**SUBJECT: CATAWBA NUCLEAR STATION, UNITS 1 AND 2 - ISSUANCE OF
AMENDMENTS REGARDING MEASUREMENT UNCERTAINTY RECAPTURE
POWER UPRATE (CAC NOS. MF4526 AND MF4527)**

AMENDMENT TO RENEWED FACILITY OPERATING LICENSE

Amendment No. 281
Renewed License No. NPF-35

Figure 3.4.3-1
(UNIT 1 ONLY)
RCS Heatup Limitations

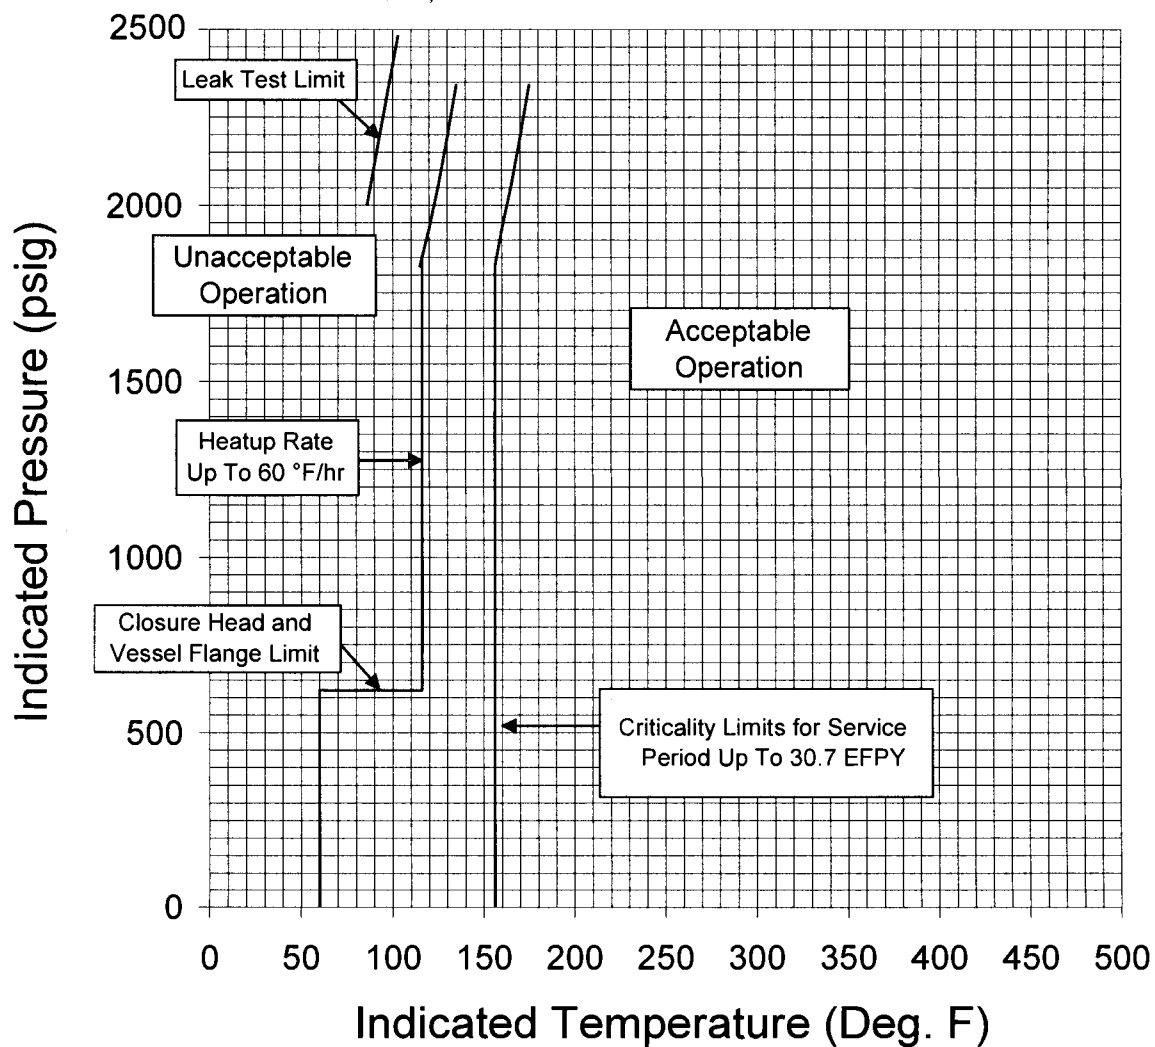
TS Figure 3.4.3-1, RCS Heatup Limitations, and Figure 3.4.3-2, RCS Cooldown Limitations

Limiting ART at 30.7 EFPY: 1/4-T, 42°F

3/4-T, 31°F
